CNWRA 2006-02
Revision 1

SUMMARY OF CURRENT UNDERSTANDING OF DRIFT DEGRADATION AND ITS EFFECTS ON PERFORMANCE AT A POTENTIAL YUCCA MOUNTAIN REPOSITORY

U.S. Nuclear Regulatory Commission
Contract NRC–02–02–012

Center for Nuclear Waste Regulatory Analyses
San Antonio, Texas

Figure 4-2. Comparison of FracMan Synthetic Fracture Populations Based on Input From (a) DOE (Bechtel SAIC Company, LLC, 2004b, Figure 6-18, p. 6-34) and (b) CNWRA (Smart, et al., 2006)

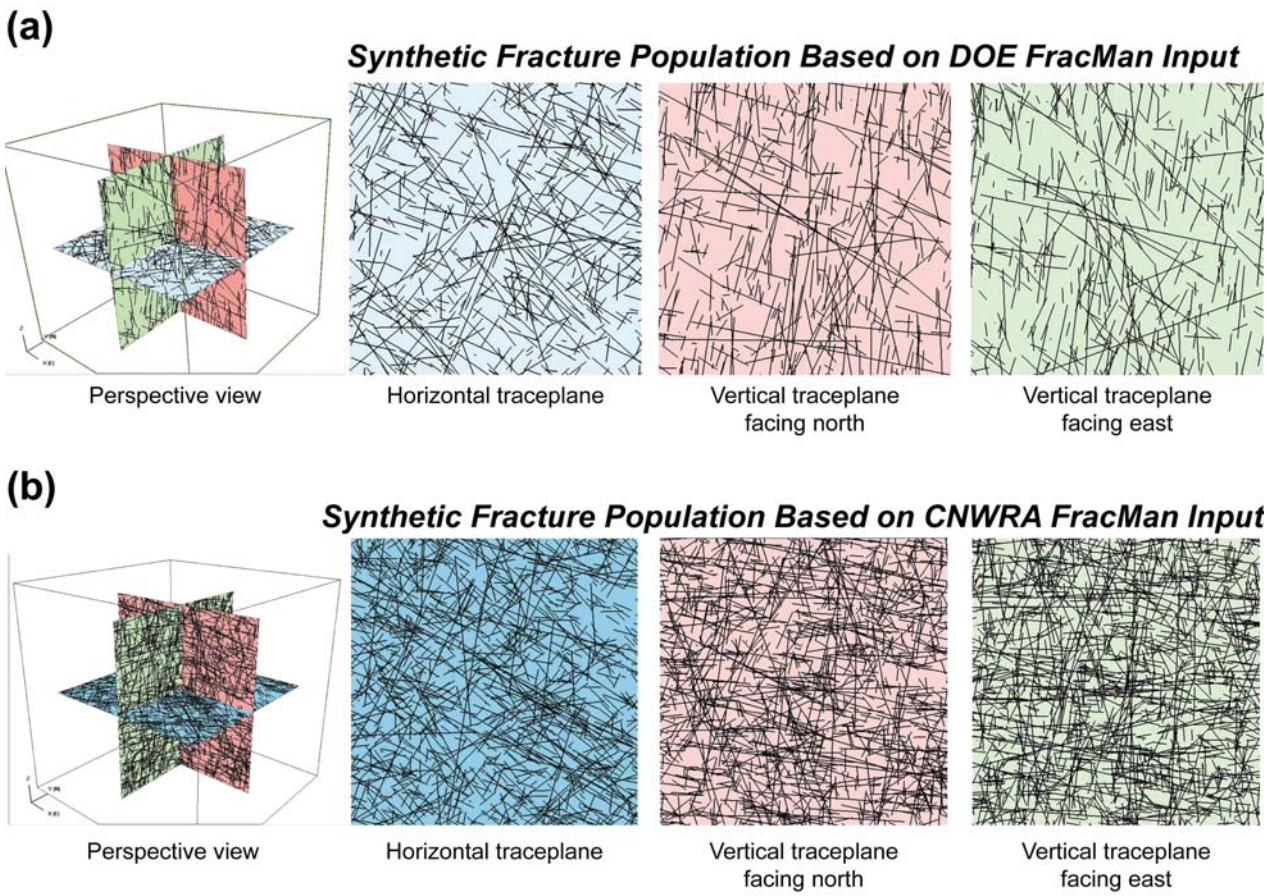
The DOE assertion that the nonlithophysal rock is dominated by nonpersistent fractures does not appear to be supported by the available fracture data. An independent review of the data (NRC, 2004, p. 18) suggests that the majority of the large scale fractures {i.e., trace lengths >1 m [3.3 ft]} abut or cut across other fractures on at least one end where visible (i.e., not obscured by engineered supports). The argument for nonpersistent fractures in the nonlithophysal rocks is further weakened if small scale fractures {i.e., trace lengths <1 m [3.3 ft]} are considered, because these may link larger fractures, thus increasing overall connectivity. Consequently, excessive use of rock bridges in the 3DEC analyses appears to have produced a

rock-mass model with fewer kinematically removable blocks than may be realistic for the nonlithophysal rock at Yucca Mountain. The DOE analysis would have resulted in greater rockfall volumes and larger changes in emplacement-drift geometry if a more accurate representation of fracture connectivity had been used.
